MK20 Yoke / DIN Dealer Service Alert July 2007

RE: MK20 Yoke/DIN Service Inspection Procedure Notice

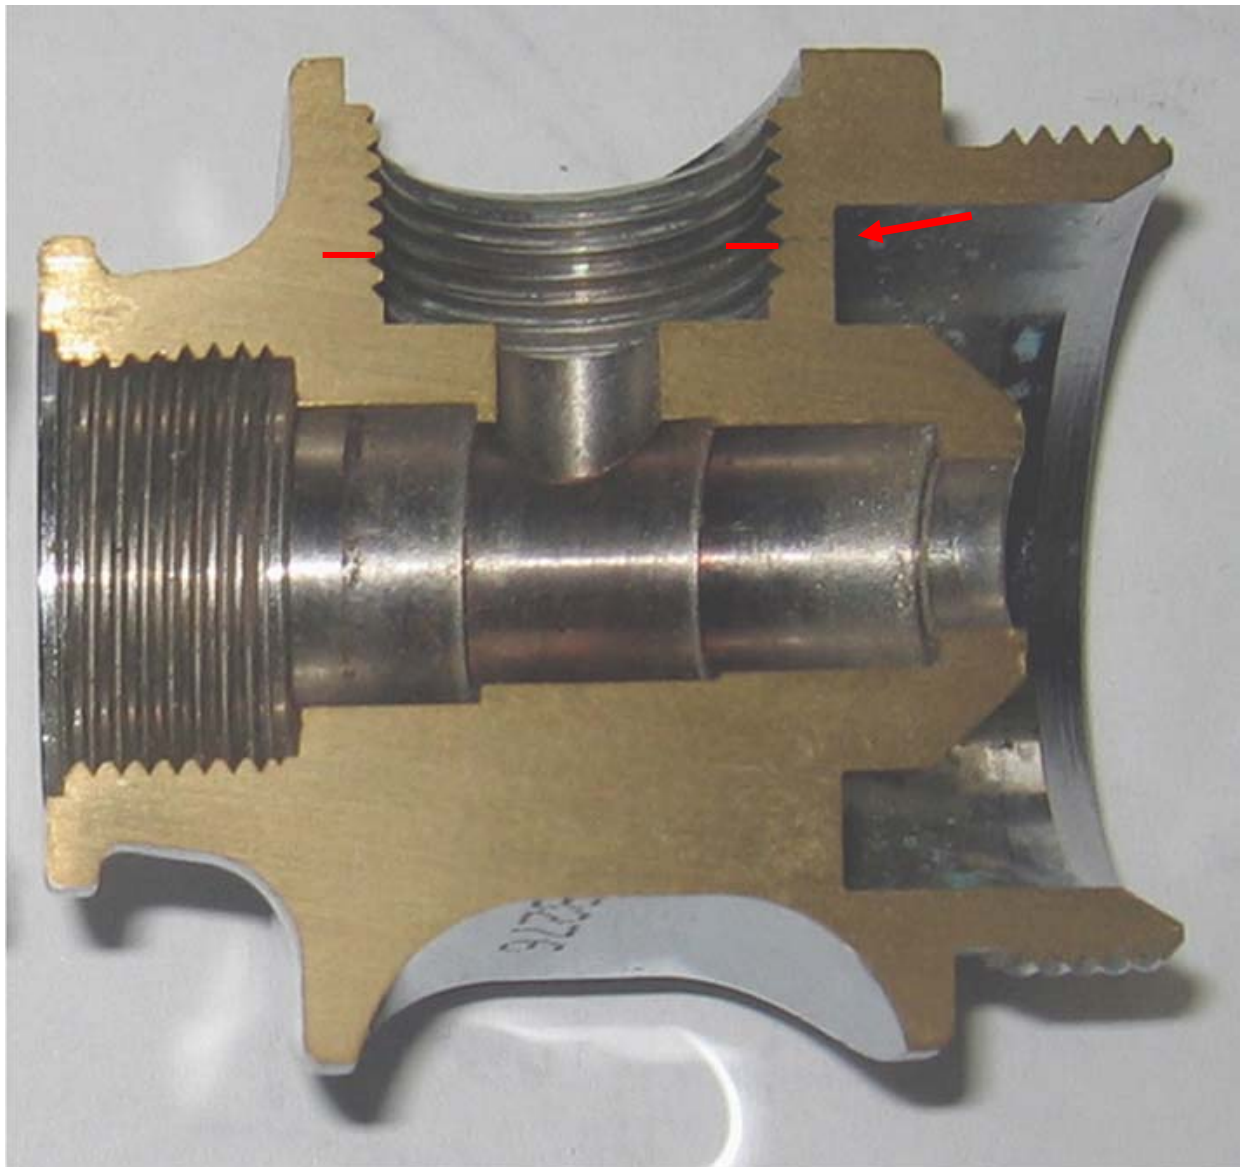
1. Fully disassemble the regulator.
2. Viewed in the cross-section, look for a pre-existing crack that begins at the base and grows into the threads at the location indicated on Figure 1.
3. Viewed on the low-pressure side of the regulator body, there is little material and a pre-existing crack will be visible at the location indicated in Figure 2. Pre-existing cracks are visible at the surface in this location to the service technician, but are likely not visible to the consumer.

Figure 1. Cross-section of an MK20 body showing a growing crack (red lines) from the root of the threads. This crack will be visible at the location indicated (red arrow) before the crack ruptures. This location is invisible to the user during use; however it will be apparent to the service technician while the regulator is disassembled.

IMPORTANT: PLEASE INCLUDE THIS INSPECTION AS PART OF YOUR ROUTINE SERVICE OF MK20 REGULATORS, AND RETURN ANY CRACKED PART TO SCUBAPRO FOR PROMPT REPLACEMENT.
